Pantera by Ghia

Technical Service Bulletin

APRIL 25, 1975

BULLETIN NO. 14

Fig. 1 – Article No. 108

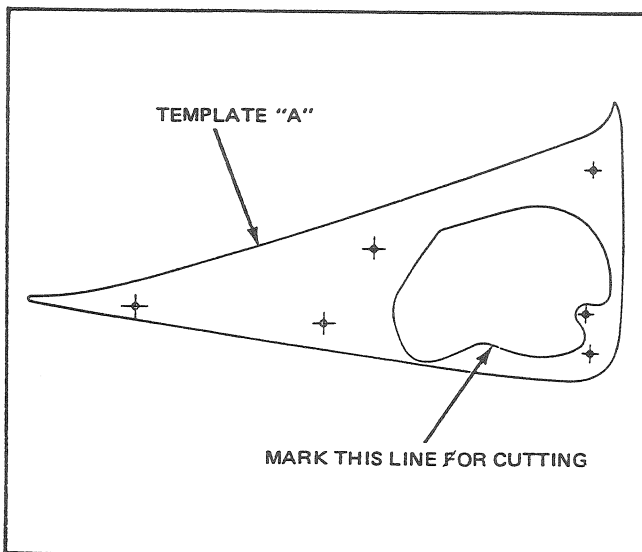
1. Open rear deck lid, remove spare wheel and tire and rear luggage compartment floor.
2. Remove the engine compartment grille attaching screws (4) and remove the grille.
3. Remove the left gas tank access cover attaching screws and remove the panel.
4. Remove the left rear wheel well splash shield attaching nuts (1) and screws (2) and remove splash shield (if so equipped).
5. From inside the left rear wheel well remove the grille attaching wing nuts (4) and remove the grille.
6. Cut out the templates supplied with the filler pipe housing (D36Y-6327936-A) and place template "A" in position on the left rear quarter panel. Mark out the position of the gas filler cap opening (see Fig. 1).

7. Using a jig or saber saw cut out the filler cap opening. Smooth any rough surfaces and paint with body color touch-up.

Fig. 2 – Article No. 108

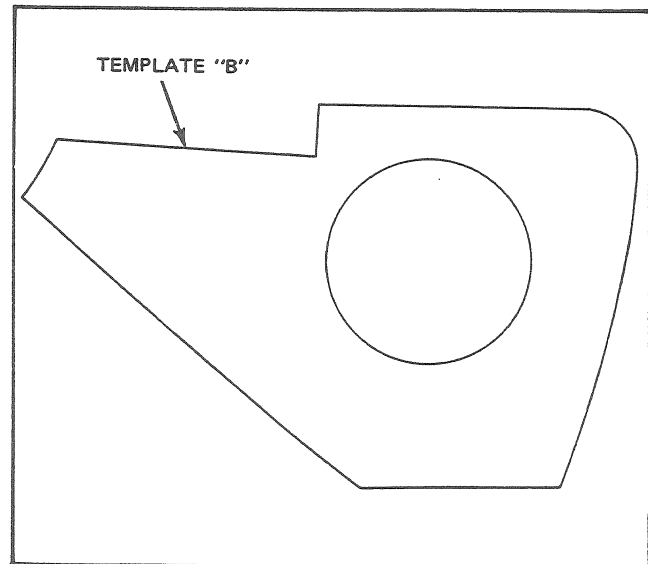
8. Remove the existing gas tank filler neck attaching bolts (4) and remove the neck and gasket. Cover the filler neck hole in the gas tank to keep out dirt and foreign material.
9. Position template "B" on the inner body panel and mark the position of the hole for cutting (Fig. 2).

10. Using the jig or saber (or 2-1/2" hole) saw, cut the hole in the inner panel. Smooth any rough surfaces and paint with body color touch-up.
11. Remove the filler neck hole covering from the gas tank. Place the gasket in position and install the new filler neck (D36Y-9034-A) to the tank using original attaching hardware.
12. Spray paint the filler pipe housing matt black.
13. Reinstall the original gas tank filler neck to the newly painted filler pipe housing using four attaching bolts, nuts and washers.

Fig. 3 - Article No. 108

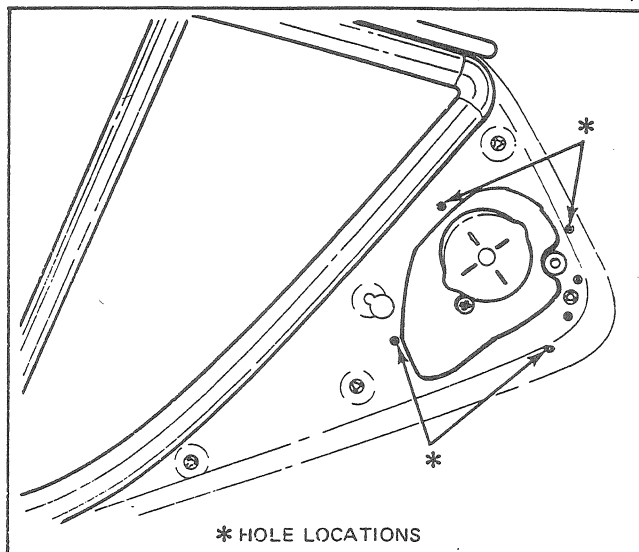
15. From behind the wheel opening, pass the housing and connecting hose through the hole in the inner panel and over the gas tank filler neck. Tighten hose clamp (finger tight).
16. Position the housing behind the quarter panel so that the right hand vertical flange is resting behind the quarter panel rear flange and the bottom flange is beneath the lower, angled edge of the quarter panel.
17. Drill four 1/8" dia. holes as shown in Fig. 3 and secure the housing assembly to the body panel with four (4) 1/8" dia. pop rivets. Paint rivets with body color touch-up.

Fig. 4 - Article No. 108

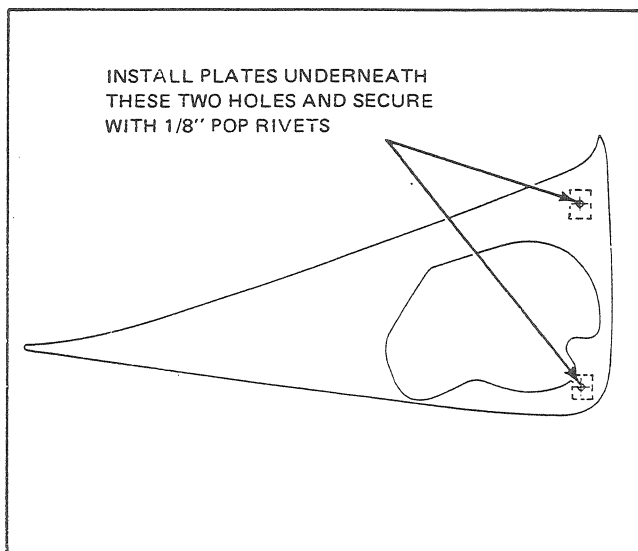
18. Adjust connecting hose and tighten both hose clamps.
19. Cut two (2) small steel or aluminum reinforcing plates 1-3/4" x 3/4" (approximately 1/16" thick). Place in position underneath the top and rear holes. Retain with 1/8" pop rivets. (See Fig. 4)

Fig. 5 - Article No. 108

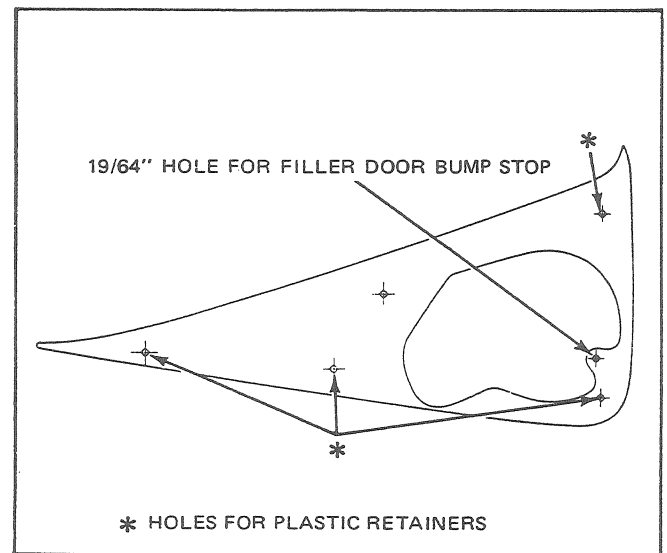
20. Replace template "A" in position, mark off and drill 5 holes (1/4" dia.) for the plastic retainers and one 19/64" dia. hole for the filler door bump stop. (Fig. 5) Paint insides of all holes with body color touch-up.
21. Insert rubber bump stop for filler cap door and four (4) plastic retainers in four of the five holes. (See Fig. 5)

Fig. 7 – Article No. 113

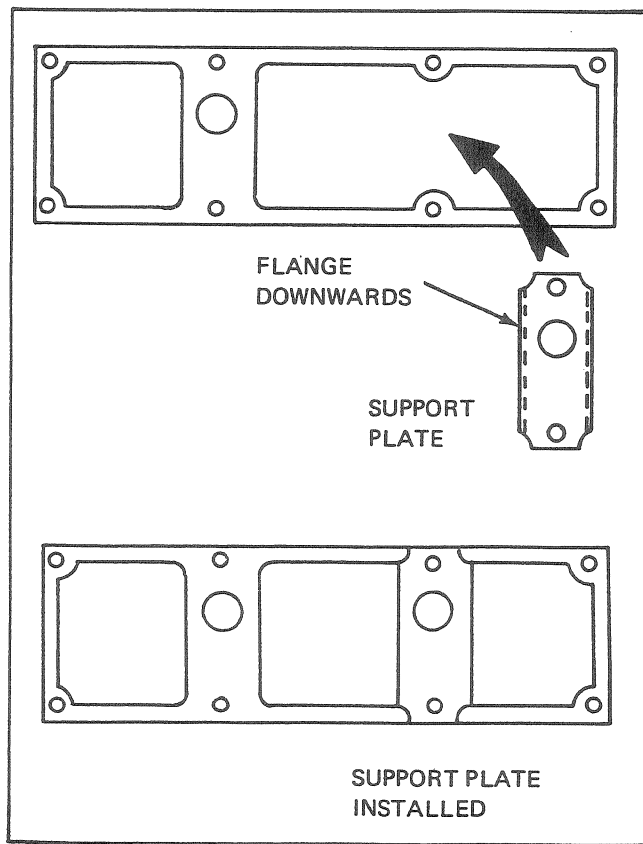
12. Check position of tubes in pivot shaft assembly. Flares of tube must locate in the slots in the outer ends of the top plate of pivot shaft assemblies.
13. Tighten four (4) retaining bolts finger tight.
14. Locate new pivot shaft support plate, flange side downwards, (with pivot hole to the top) to the left of the existing mounting in the cowl openings. (See Fig. 7)

Fig. 6 – Article No. 113

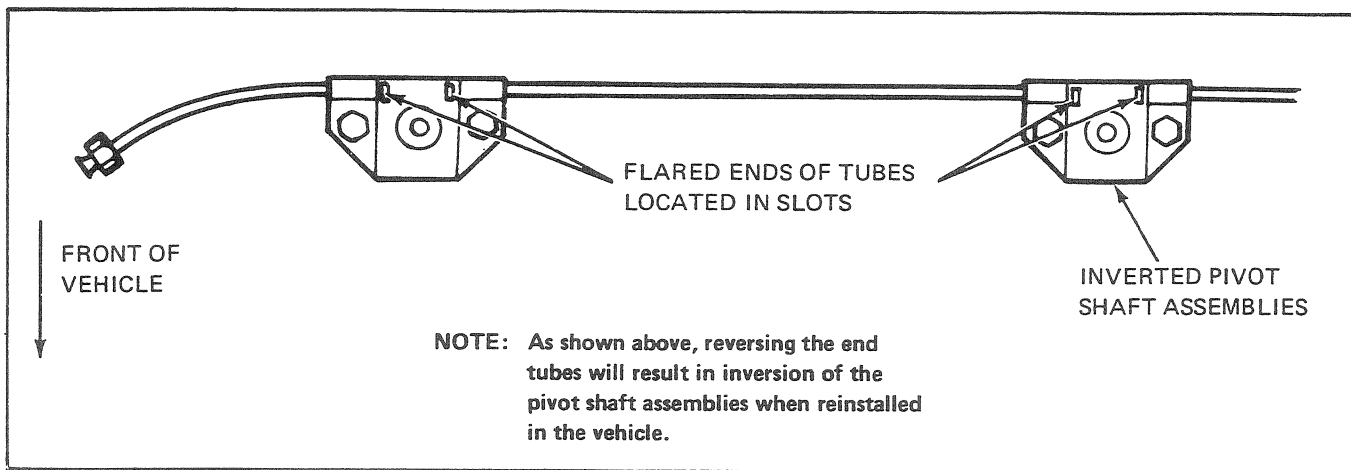
Effective with the 1974 model (Chassis No. 05900), the windshield wiper system was redesigned to provide parking on the right side on the windshield. In addition, a reduced arc gear was incorporated in the motor to prevent the possibility of wiper blade over-travel. This new gear cannot be used on 1971-1973 models unless the complete system is revised to the 1974 levels as follows:

11. Install new curved tube, (5-1/2 inches longer) to left pivot shaft. (See Fig. 6)

Fig. 8 – Article No. 113

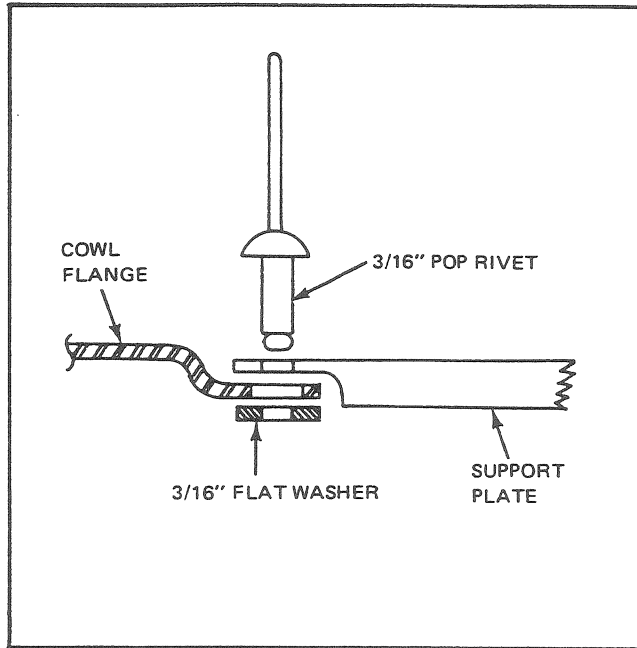
15. Attach pivot shaft support plate to cow' flange using two 3/16" dia. pop rivets with a 3/16" d'. flat washer under cowl flange. (Refer Fig. 8)

Fig. 9 – Article No. 113

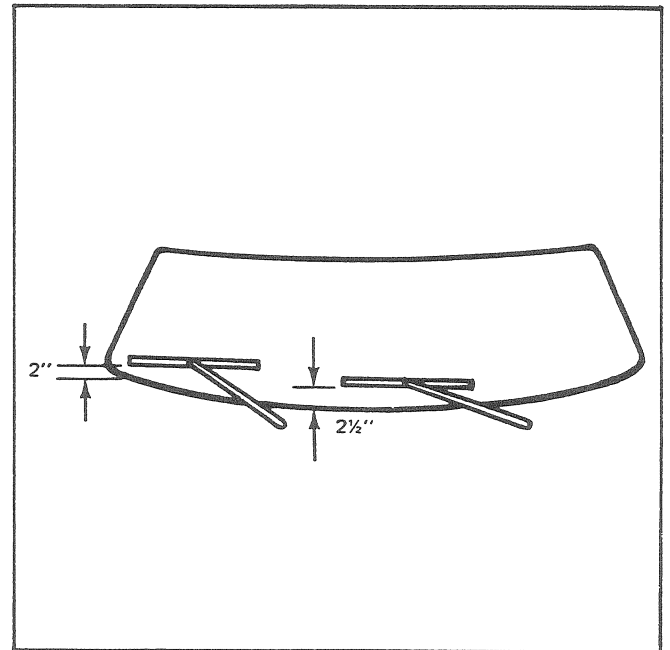
24. Install short wiper arm and blade assembly on passenger side of vehicle so that the furthest edge of the wiper blade is 2.00 inches above the windshield lower rubber weather seal. (See Fig. 9)

25. Position the long wiper arm and blade assembly on the driver's side so that the furthest edge of the wiper blade is initially located 2.50 inches above the windshield lower rubber weather seal. (Fig. 9)
26. Thoroughly clean windshield, then apply a heavy spray of water with a hose over the entire windshield surface. Run engine, turn on wiper system to high speed and, while continuing to spray water, observe wiper operation. The driver's side wiper blade should come close, (from 1/2 inch to possibly "ticking") the windshield "A" post rubber weather seal under these conditions.
27. If excessive blade slap or weather seal override is noted, re-adjust driver's blade by backing off arm assembly one serration only and retest.
28. Install windshield wiper motor shield and right road wheel and lower car.

Fig. 10 – Article No. 116

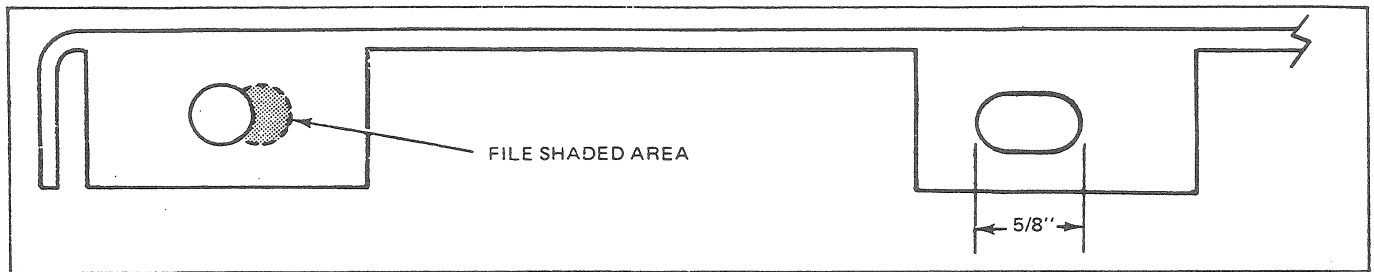
The 1974 model (Chassis No. 05900) headlamp concealment motor will be stocked for servicing 1971-1973 models; however, it will be necessary to revise the motor support plate and wiring to the 1974 levels. This can be accomplished as follows:

9. Remove the rubber grommets and four (4) aluminum spacers from the motor mounting hole in the mounting plate.
10. Using a 1/4" diameter round file elongate the mounting holes inboard to accommodate studs on new motor. (See Fig. 10)

Fig. 11 – Article No. 116

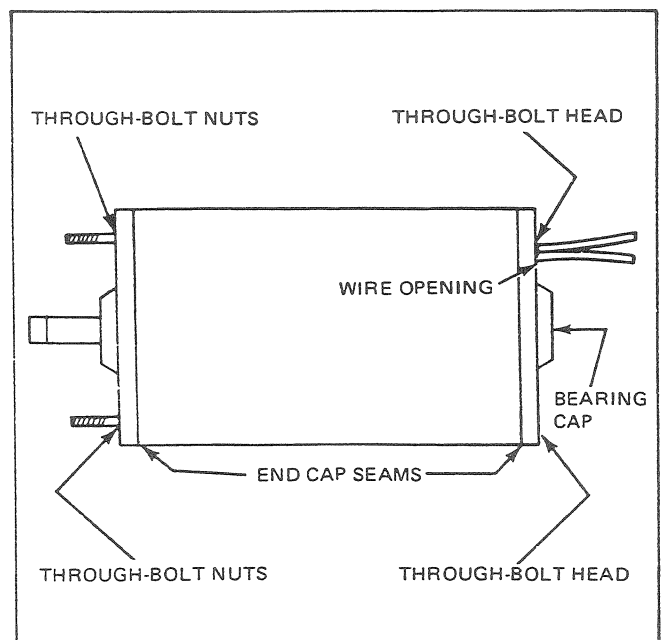
12. Seal the following areas on the new motor using suitable silicone sealant. (See Fig. 11)
 - Around both end cap seams.
 - Around the aperture for the two motor wires.

- The end bearing cap.
 - The heads of the two through bolts in the end cap and the corresponding nuts in the opposite end cap.

Fig. 14 – Article No. 116

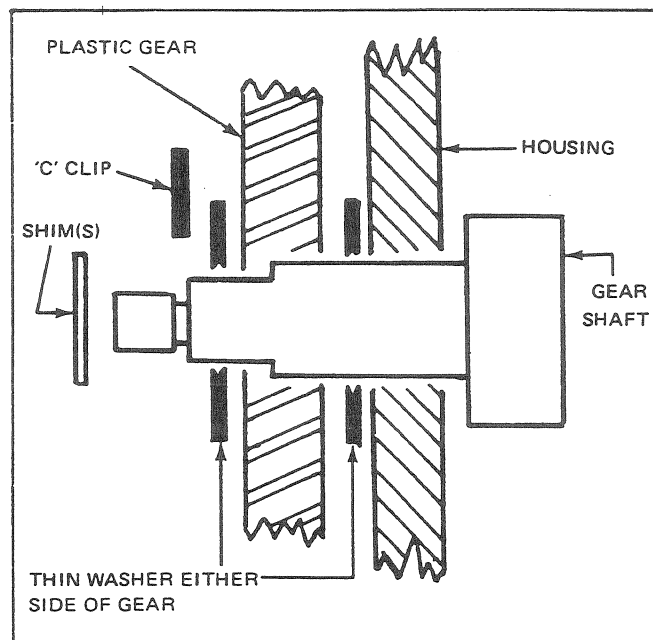
18. Apply thin coating of low temp grease to worm gear in housing. Apply thin smear of grease to gear shaft and insert into housing. Place flat washer over shaft. Apply thin smear of grease only on teeth of plastic gear. **Surplus grease must be removed from flat surfaces of gear.** Replace thin washers and retain gear shaft in position with existing "C" clip. Replace original number of shims over pinion shaft. (See Fig. 14)

Fig. 15 - Article No. 116

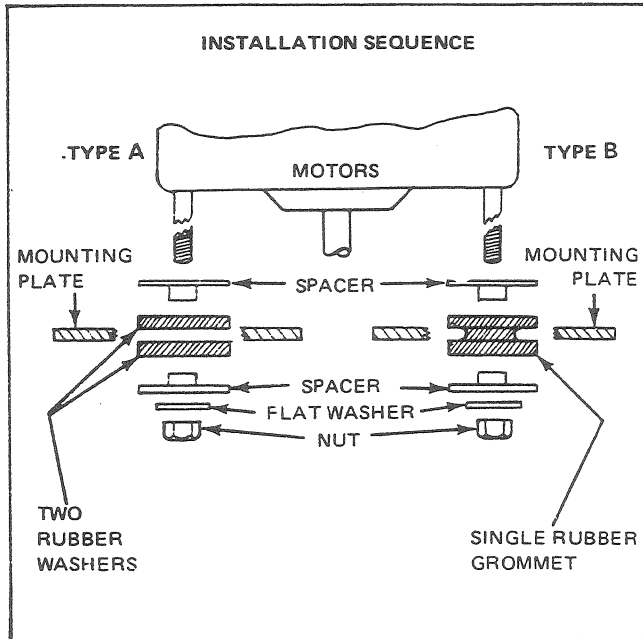
22. a) Install one rubber washer and spacer on each mounting stud of new motor. (See Fig. 15) Position motor in

flexible coupling on the main drive gearbox shaft. Install second rubber washer and spacers on motor studs and retain to the mounting bracket with original nuts and flat washers.

Fig. 16 - Article No. 116

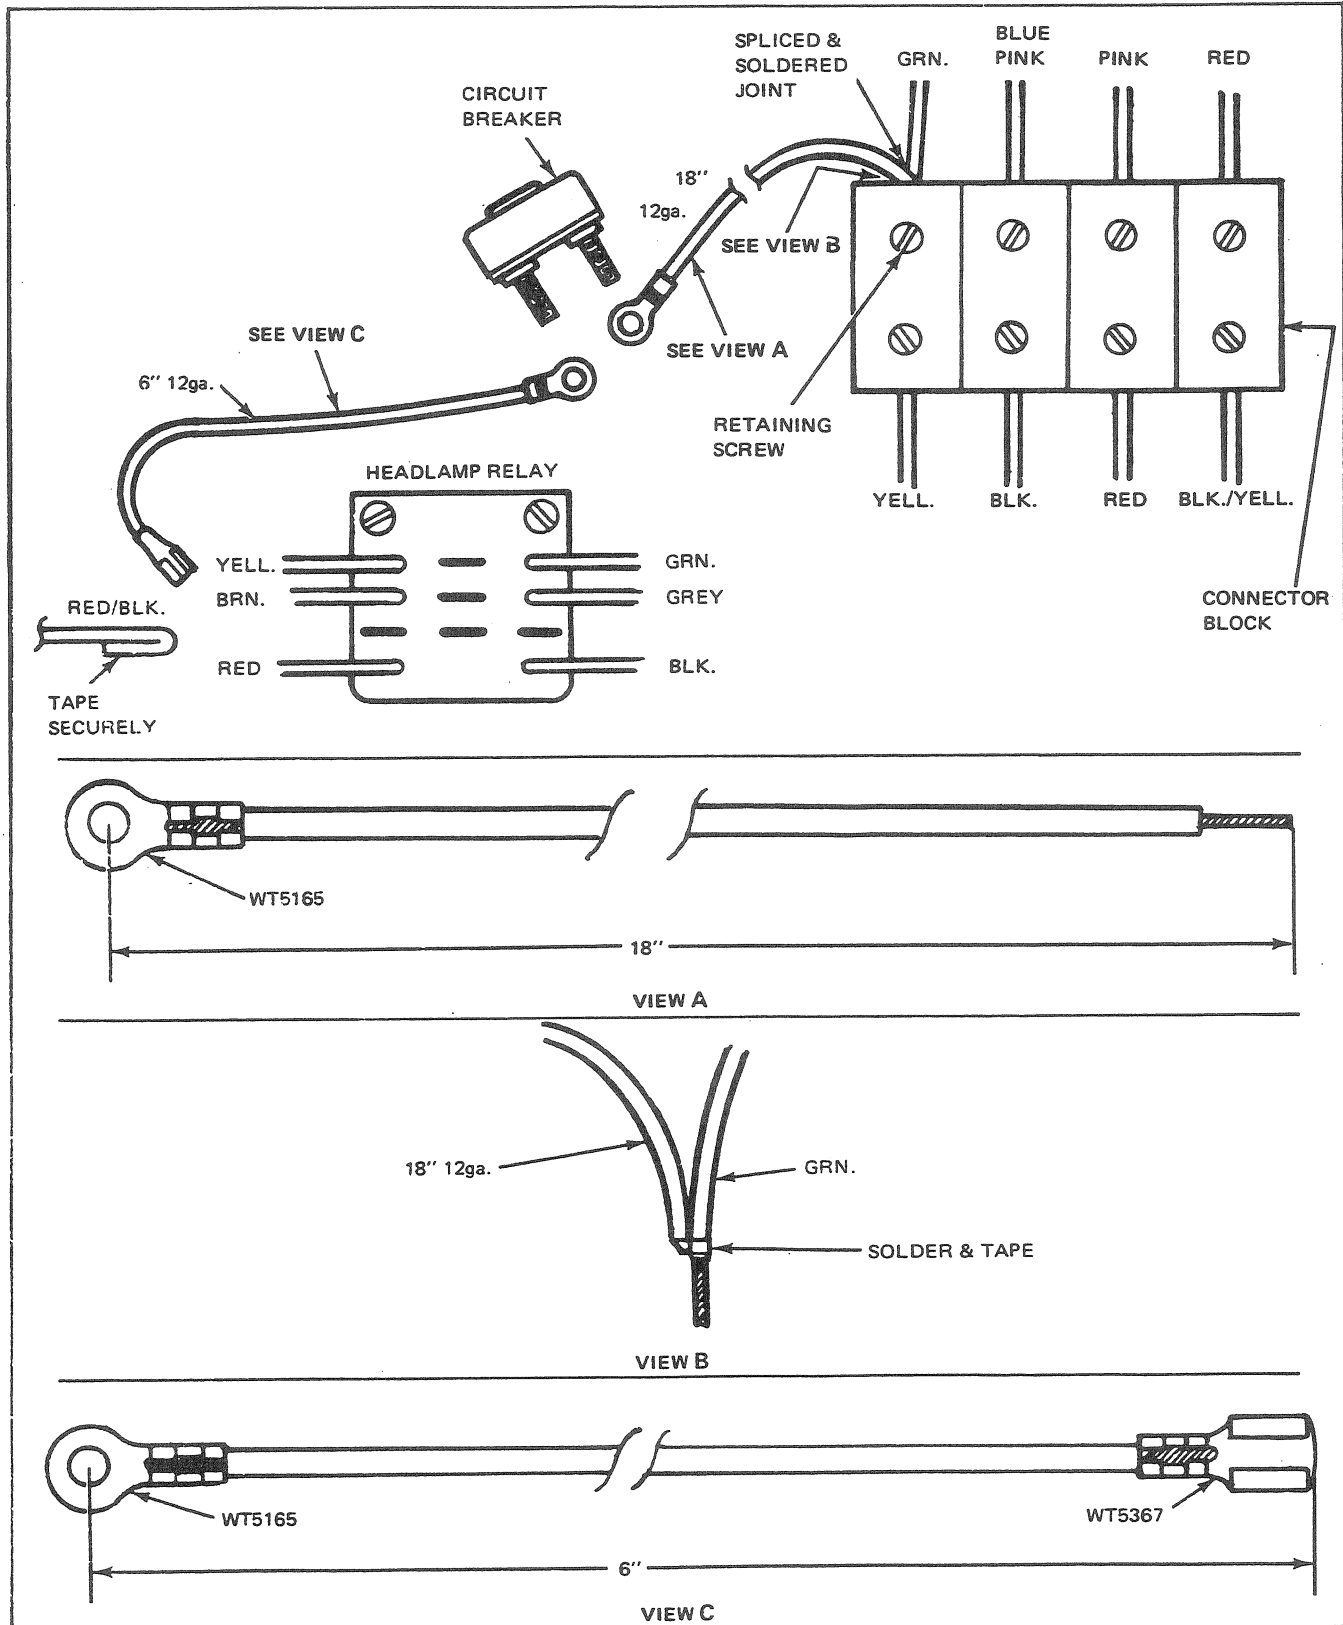
36. Fabricate piece of 12 gauge wire 18 inches long, bare both ends 1/4" - 3/8". Crimp and solder eyelet terminal to one end. (See Fig. 16 - View A on page 12).

38. Solder wire fabricated in step 36 (18"-12 ga.) to the newly bared portion of the green wire. (See Fig. 16 - View B on page 12). Tape securely and reconnect to connector block. Tighten screw.

40. Attach eyelet to one post on 30 amp. circuit breaker and secure with No. 10-24 nut. (See Fig. 16 on page 12).

42. Fabricate piece of 12 gauge wire 6 inches long. Crimp and solder eyelet terminal to one end and female terminal to the other end. (See Fig. 16 - View C).
43. Attach eyelet terminal to other post on circuit breaker and install No. 10-24 nut. (See Fig. 16) Using electrical tape, carefully wrap wires and circuit breaker terminals.
44. Remove screw retaining relay box door and open door.
45. Remove the two screws retaining the headlamp relay (clear plastic cover) to the mounting bracket and remove the relay.
46. Disconnect red wire with black tracer from its terminal on the headlamp relay and connect spade end of wire fabricated in step 42 to this terminal. Fold back and tape up the end of the red/black wire.
47. Reposition headlamp relay on mounting bracket and replace the rear retaining screw.

Fig. 17 — Article No. 116

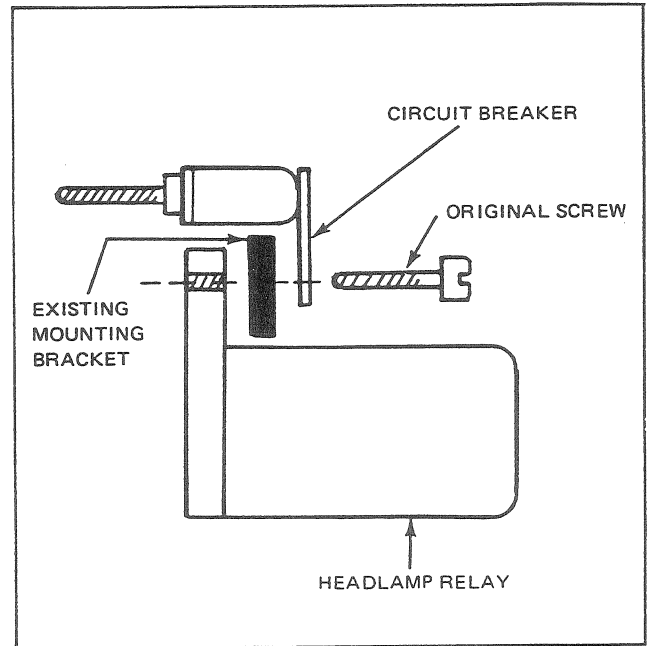
48. Place circuit breaker in position at forward screw hole with terminals facing rearward and install circuit breaker and headlamp relay to mounting bracket original screw. (See Fig. 17)
